Service Bulletin FSN-30

Subject: NC-300 Changes

Bulletin Number FSN-31

Bulletin Number FSN-34

A shielded lead should be constructed as shown below:

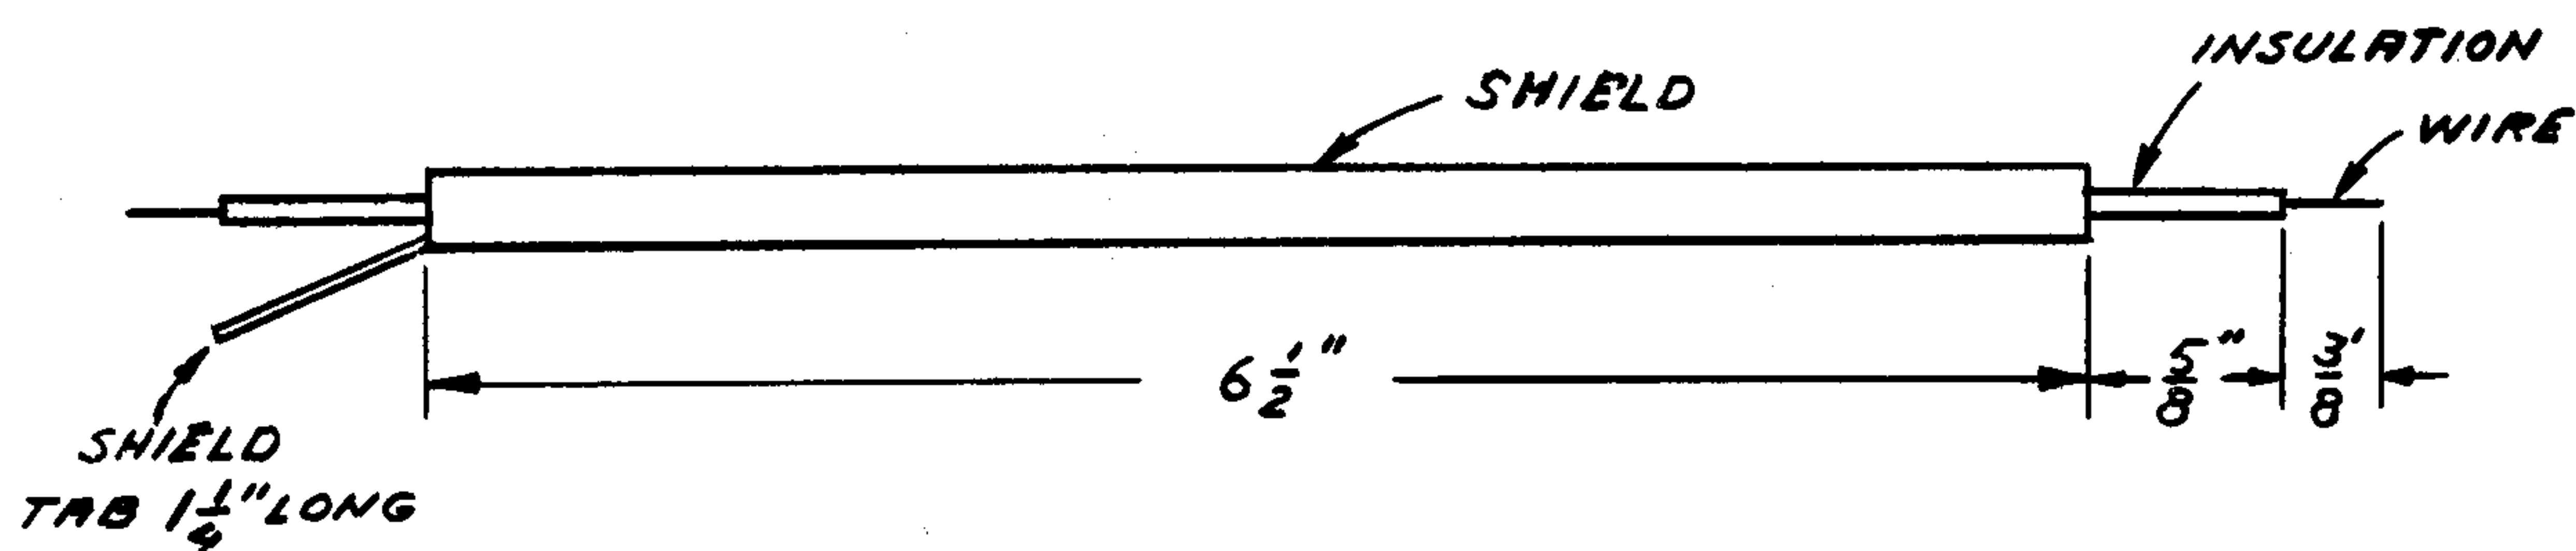
A considerable improvement in the response of the NC-300 receiver to this spurious frequency can be effected by the following modifications:

- A. Replace shielded lead from L4 to grid of second converter, V3 with above lead, placing it under phasing control shaft as shown in the pictorial diagram below.

BOTTOM VIEW

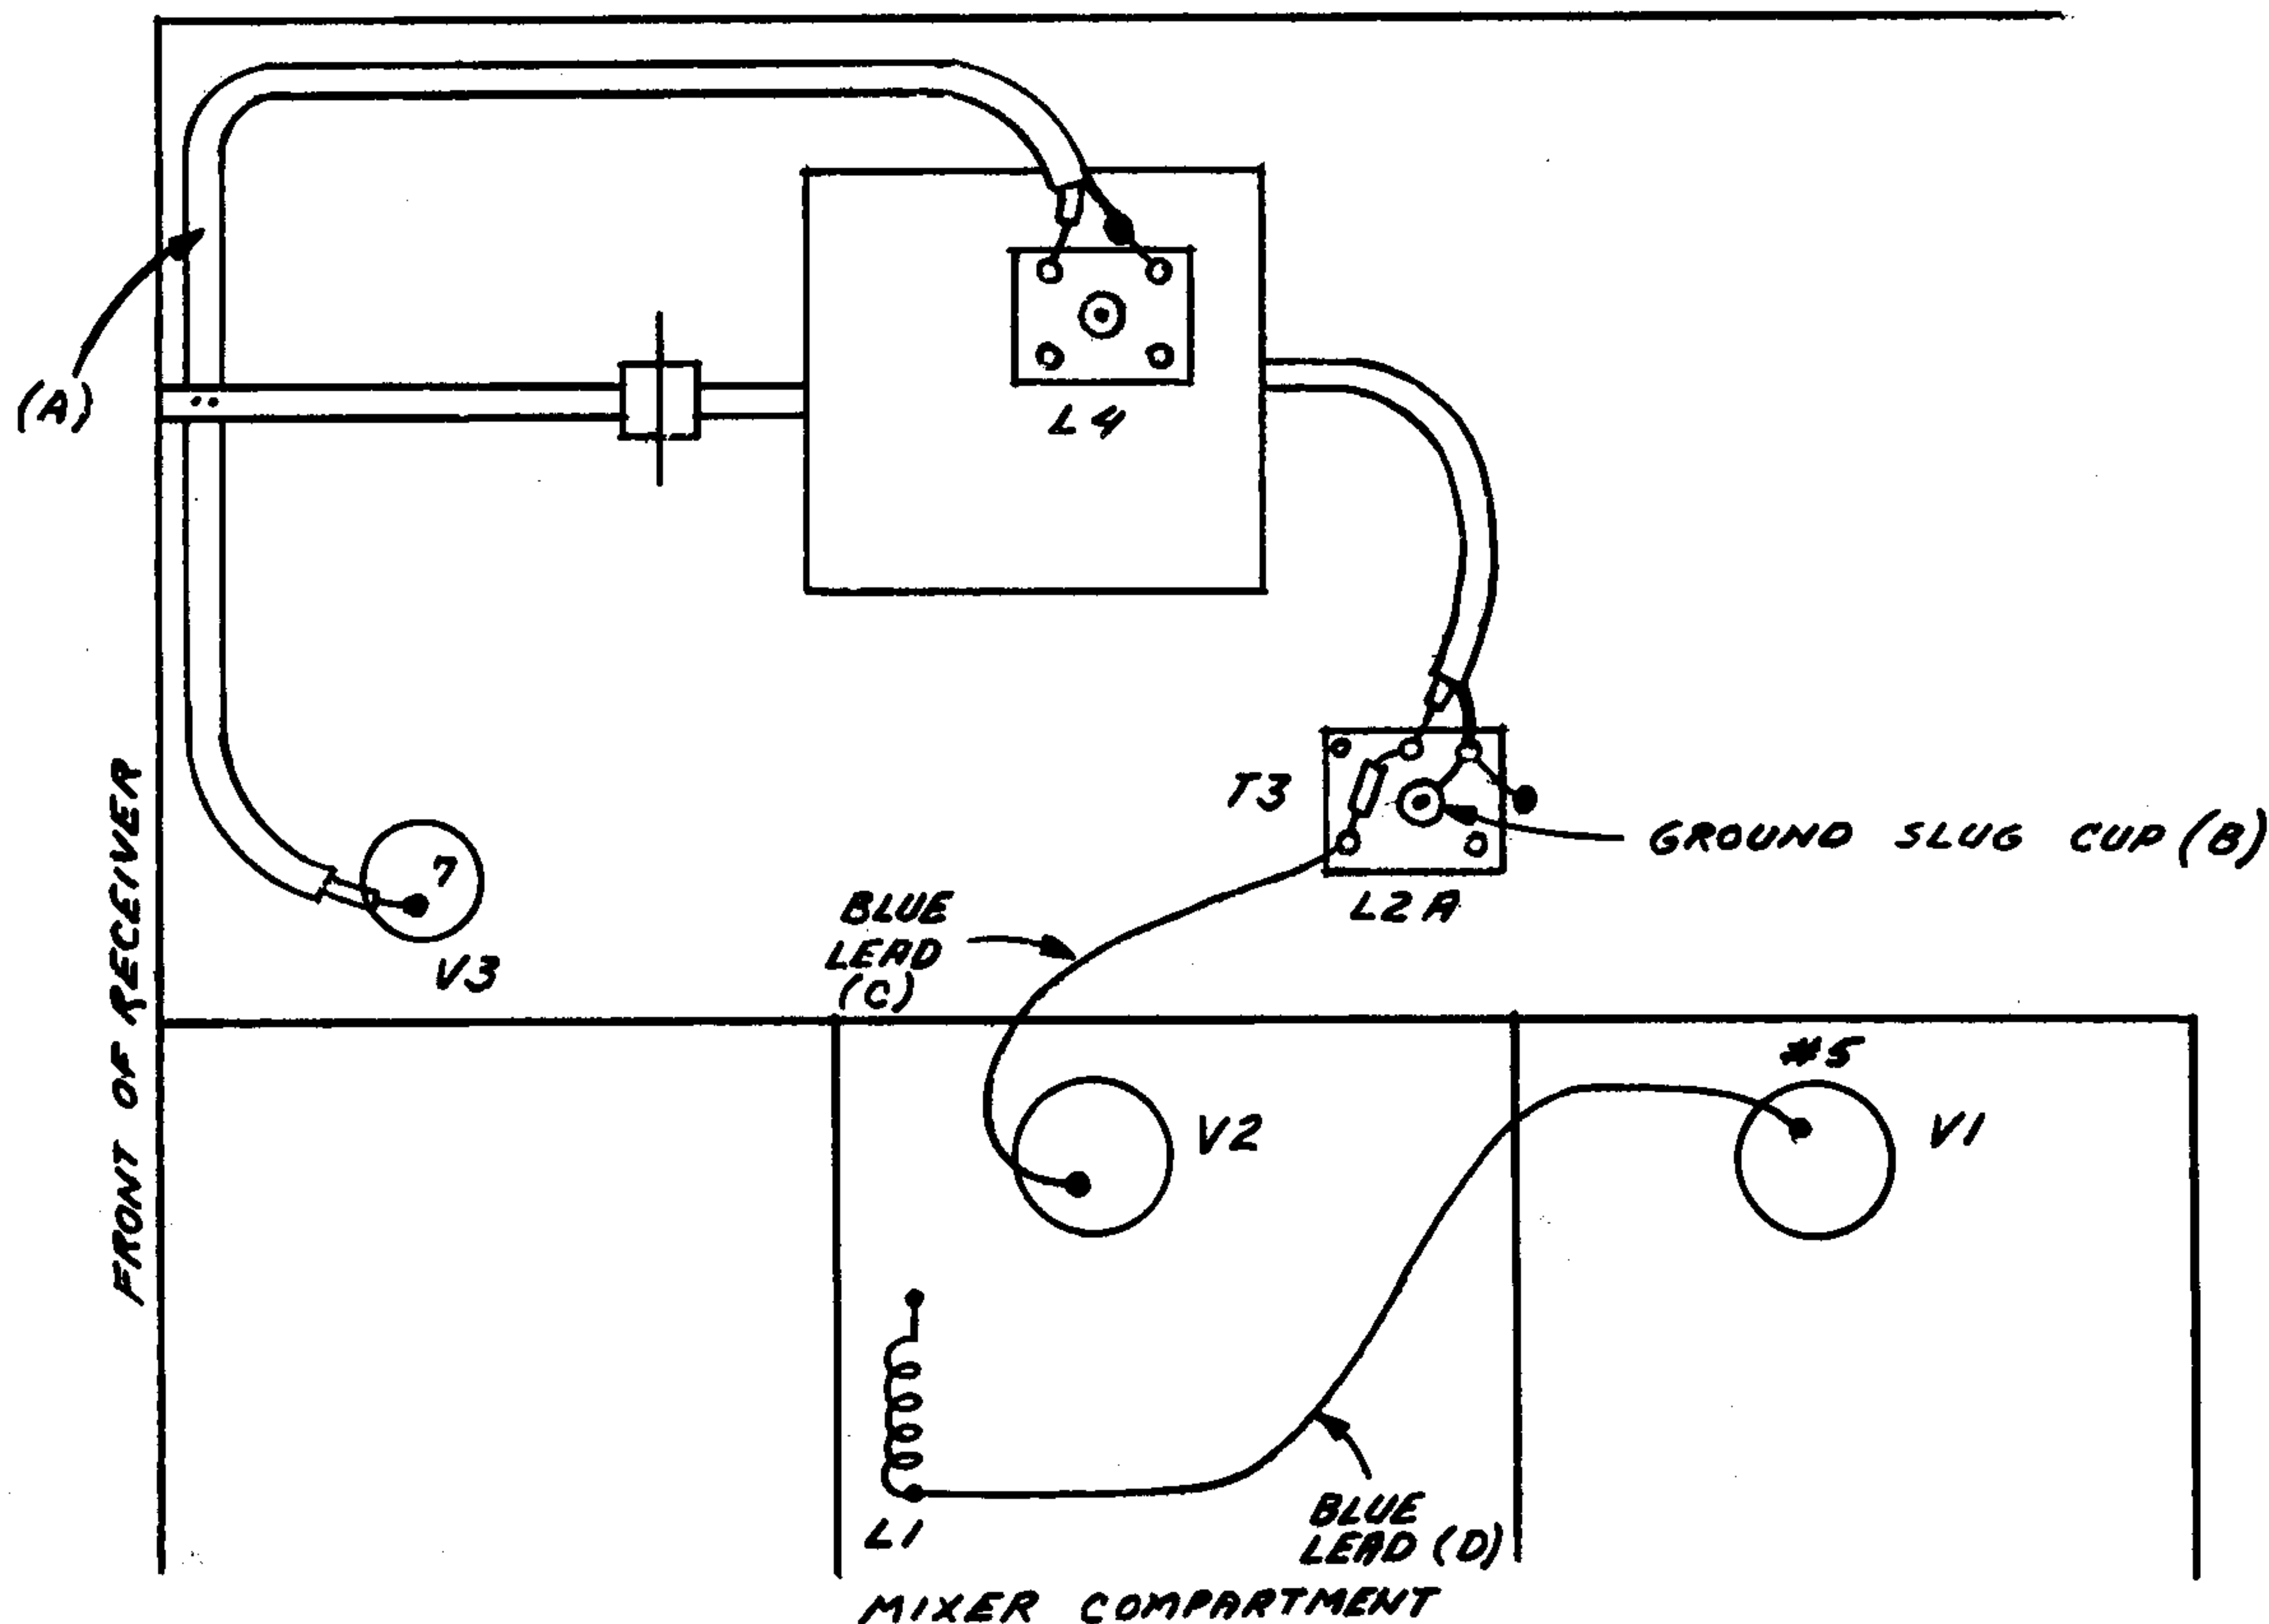
- B. Ground the slug cup of T3, as shown, with a short piece of bus wire.
- C. Push blue lead from T3 to first mixer, V2 (6BA7), against the chassis for its entire length.
- D. Push blue lead from the plate of the R. F. amplifier, tube V1, to choke L1 down against the chassis for its entire length.
- E. Repeak eight trimmer capacitors (all in a row) in the mixer compartment for maximum background noise in the middle of each range.
- F. Recheck alignment of L2A and L4. With receiver on AM and Phasing Control peaked, select at off and I.F. at #2. Trim the slug of L2A for maximum background noise.

Revised circuit below:

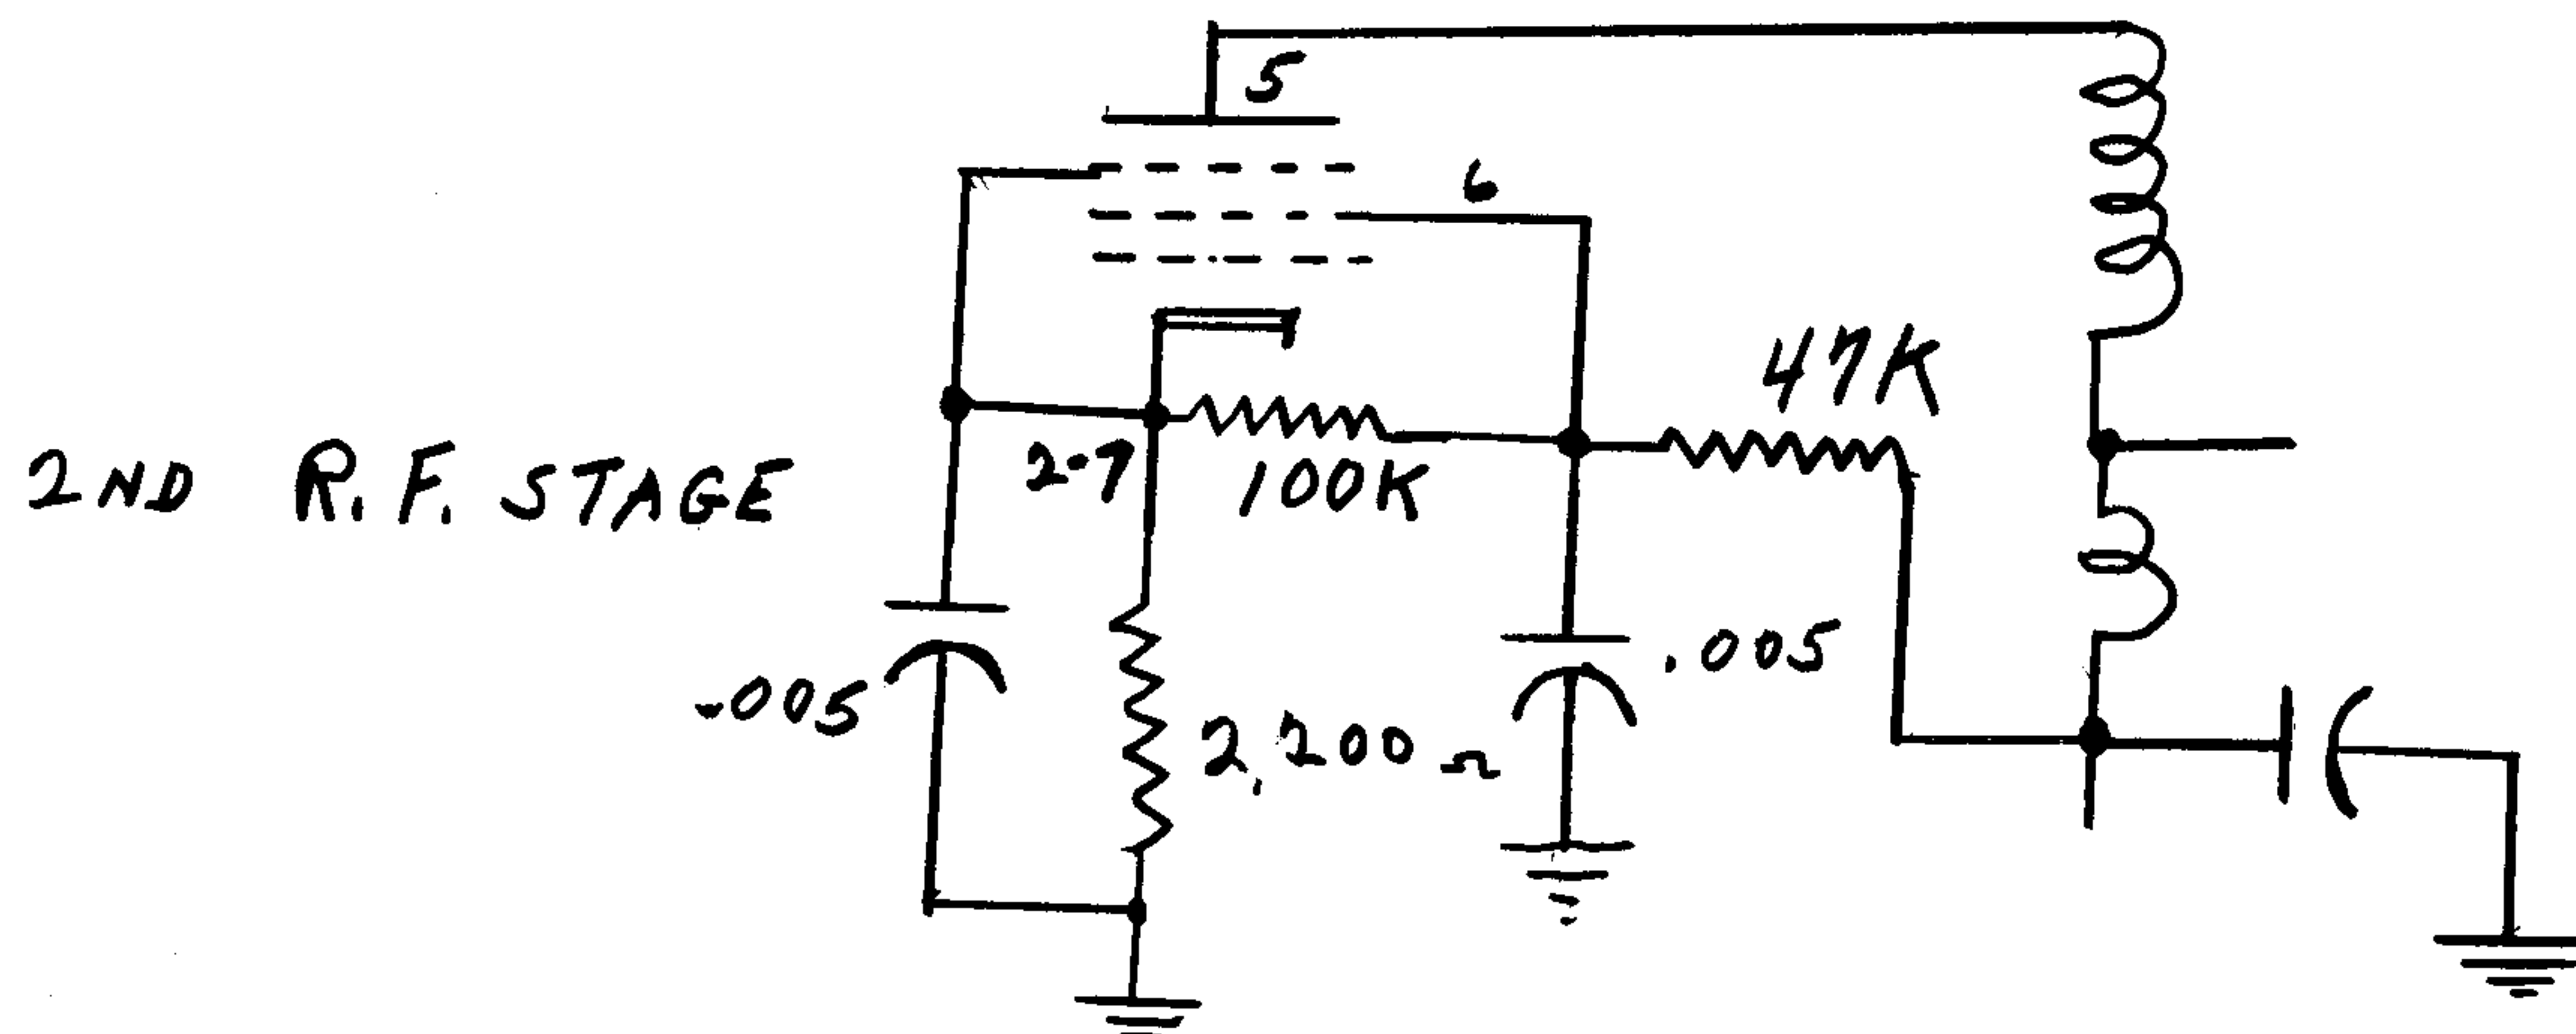
The following changes are recommended in the 6-meter converter to reduce cross-modulation:

Change cathode resistor in 6AK5 2nd R.F. amplifier stage from 470 ohms  $\frac{1}{2}$  watt to 2200 ohms  $\frac{1}{2}$  watt

A 100,000 ohm  $\frac{1}{2}$  watt resistor should be connected between Pin #6 and Pin #2 - 7 of the same 6AK5 2nd R.F. stage

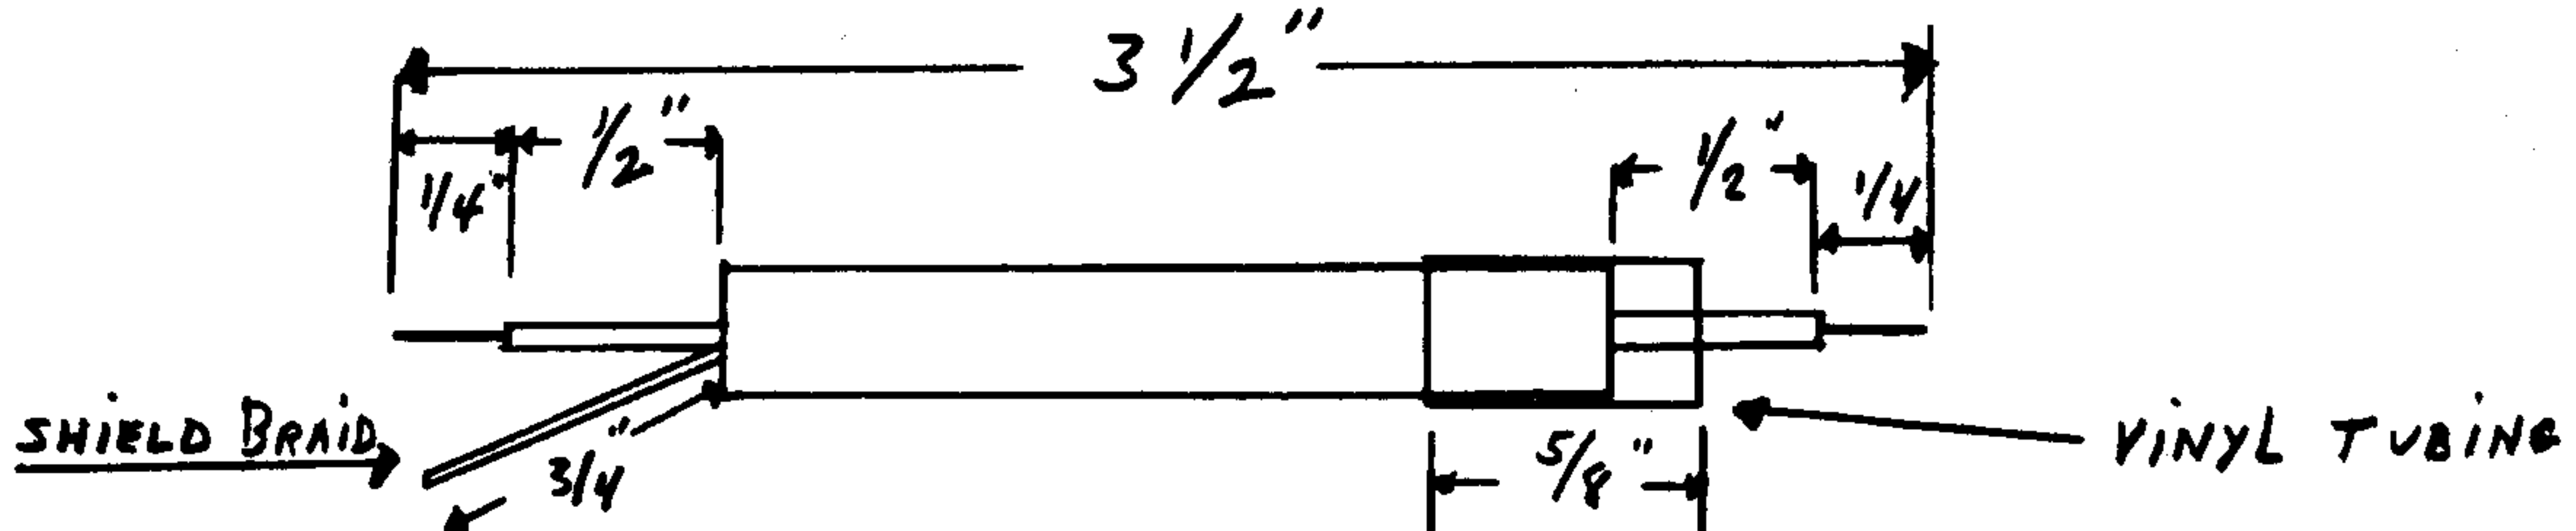
1. One shielded cable should be substituted for the blue lead connecting the plate of the first mixer (V2 Pin No. 9) to T3 (B). Drawing of cable below. The vinyl tubing is used to prevent grounds to other sections of the circuitry. Shield tab can be connected to the slug cup of L2-A which should already be grounded in accordance with FSN-33. It may be necessary to repeak L2-A after installation of this shielded lead.

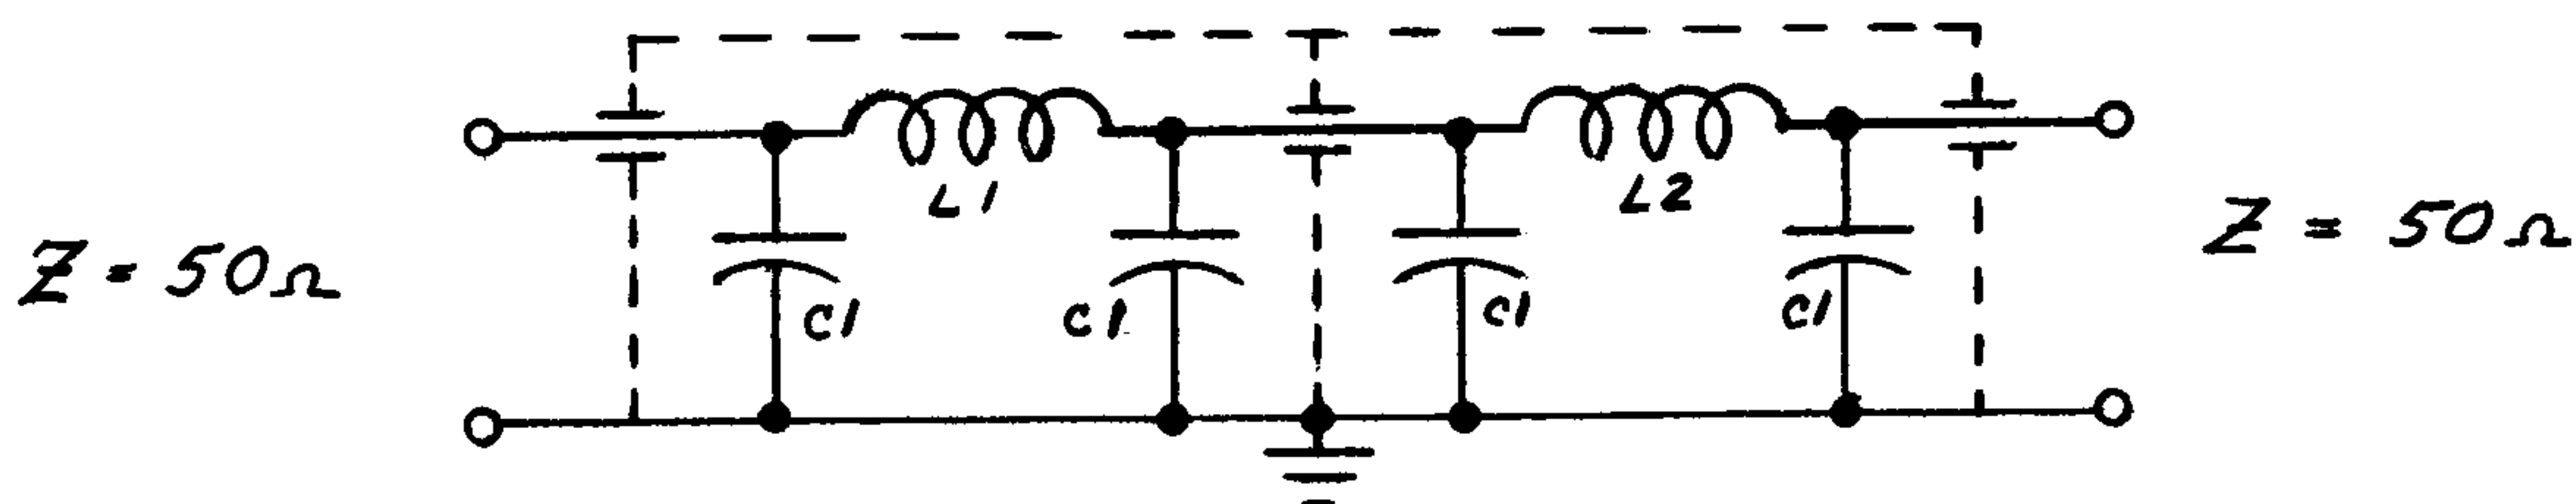
In certain metropolitan areas, I.T.V. is experienced on the 21 mc, 28 mc and X bands of the NC-300. This can be minimized by proper selection of antenna and the use of a low pass filter shown in the diagram below. This filter should be inserted in series with the antenna and located as close as practicable to the antenna terminals on the back of the chassis. A good earth ground helps considerably.

L1 = .4 uh      10 Turns #20 on 3/8" form spaced 1/2"  
L2 = .4 uh  
C1 = 80 uuf Ceramic
